USAAEFA PROJECT NO. 79-13

CLIMATIC LABORATORY EVALUATION YCH-47D HELICOPTER

FINAL REPORT

FIGURE 1
HYDRAULIC ACCUMULATORS
YCH47D US ARMY S/N 76-8008

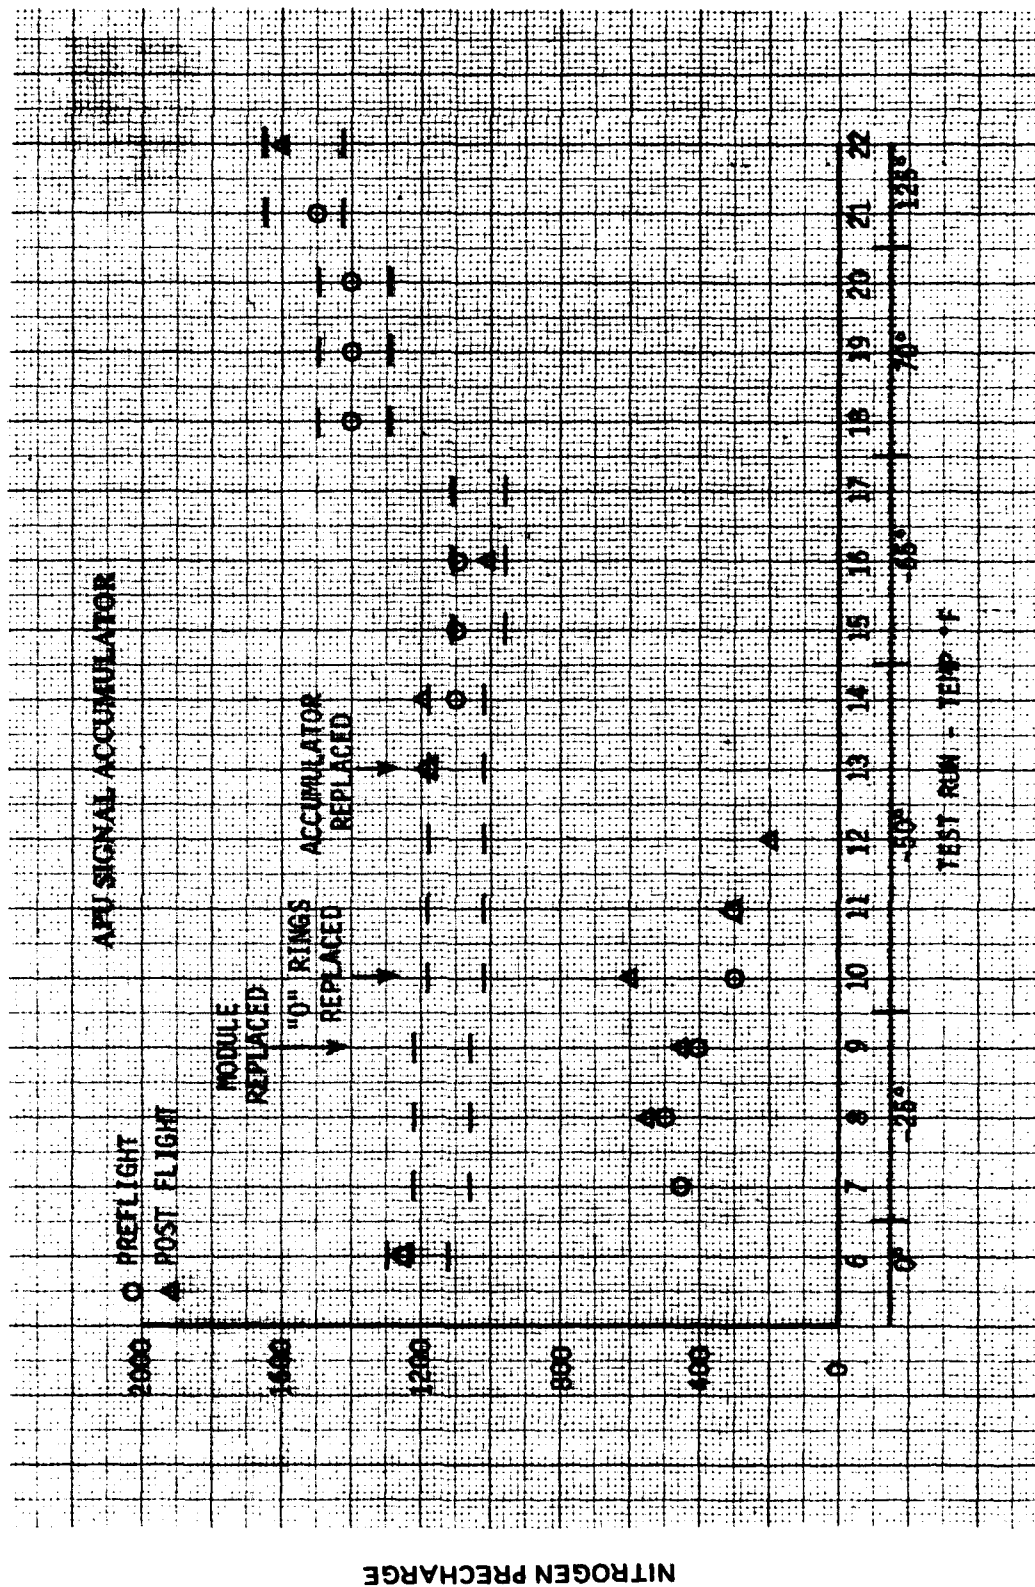
l. Paragraph 64h. The coarse scale and small size of the accumulator indicators are inconsistent with the stated precharge pressure. However, these are the standard indicators which are still satisfactory for use. Consequently, there are no plans to redesign.

46. At temperatures below -25°F the accumulator assemblies generally failed to hold a precharge. A record of accumulator pre- and post-run pressures is included in appendix F. The APU signal accumulator's performance (fig. 1), is a typical example. Figure 1 presents the pre- and post-run precharge pressures versus run/temperature. Prior to run 9 the entire APU Start Module, which includes the signal accumulator, was replaced with no improvement noted. Prior to run 10 all "O" rings from the shrader valve and gage, were replaced. Oversized "O" rings were used to complete the testing. Prior to run 13 the signal accumulator, valve and gage were again replaced which apparently corrected the problem with the signal accumulator/start module. Photo 7 is a typical Shrader valve/gage installation on all accumulators and all had similar problems. The inability of the hydraulic system accumulator assemblies to hold a precharge below -25°F is a shortcoming.

FIGURE 2
HYDRAULIC ACCUMULATORS
YCH-47D US ARMY S/N 76-8008

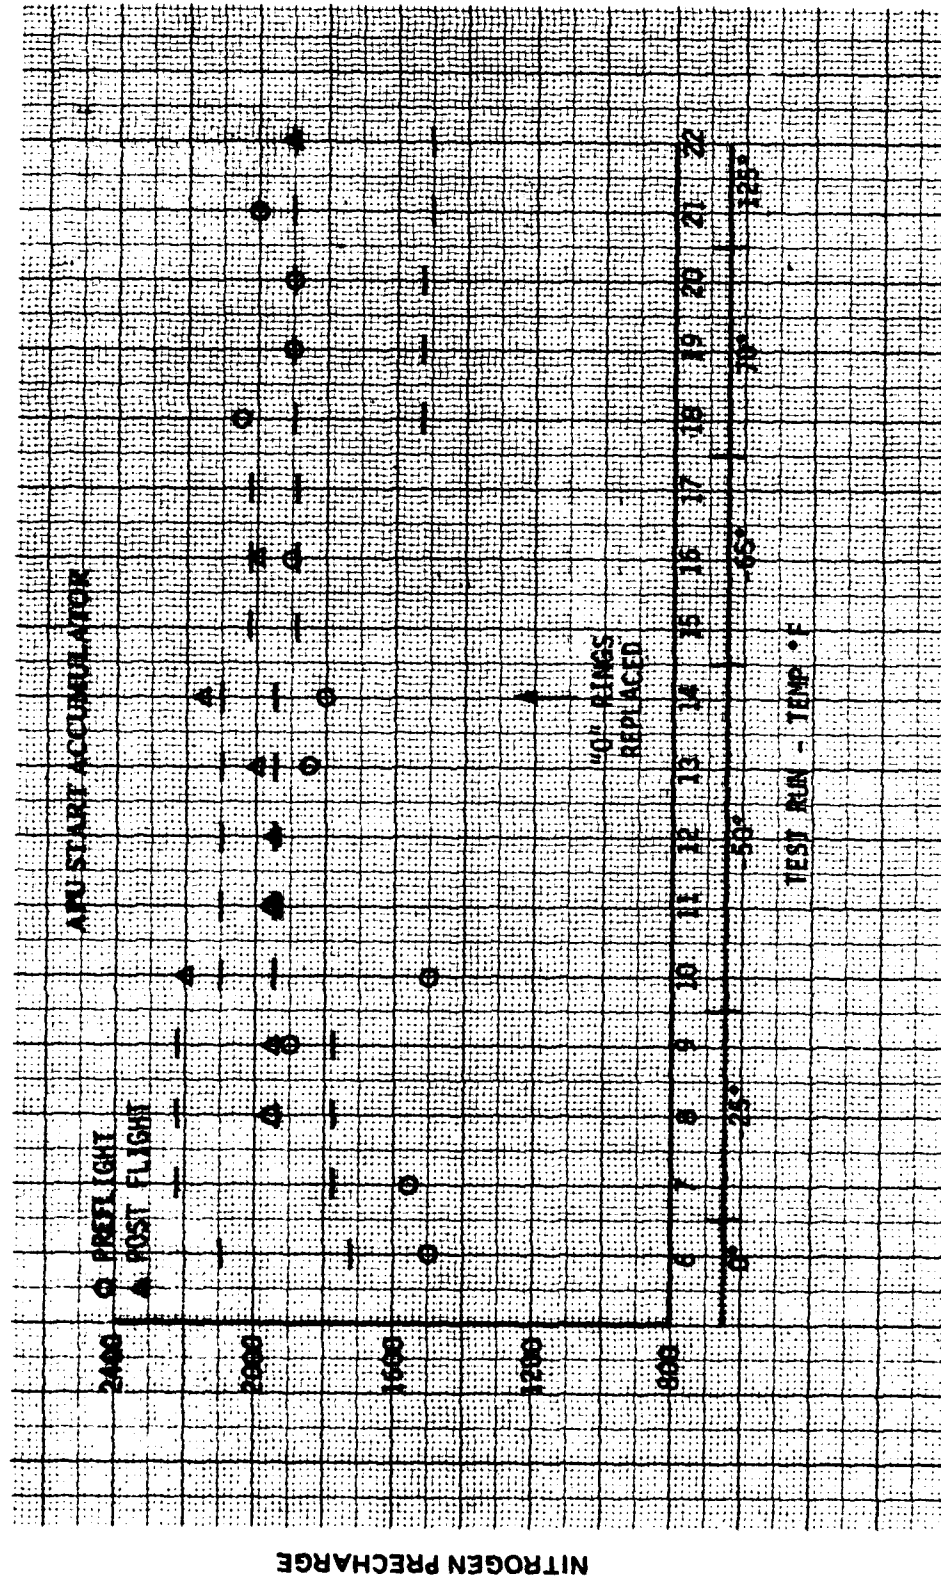
p. Paragraph 64n. The hydraulic system servicing required following a temperature change is associated with the shortcoming reported in paragraph 64b

47. The hydraulic accumulators precharge pressures do not remain within the handbook pressure tolerance band following a temperature change. Figure 2 presents the pre- and post-run pressures with handbook range versus run/temperature. The pressures were rarely within the tolerance band and it was necessary to service the accumulators before and after each run. The hydraulic system servicing required following a temperature change is a shortcoming.

of the report. This shortcoming was corrected and hydraulic system servicing should no longer be required following a temperature change.
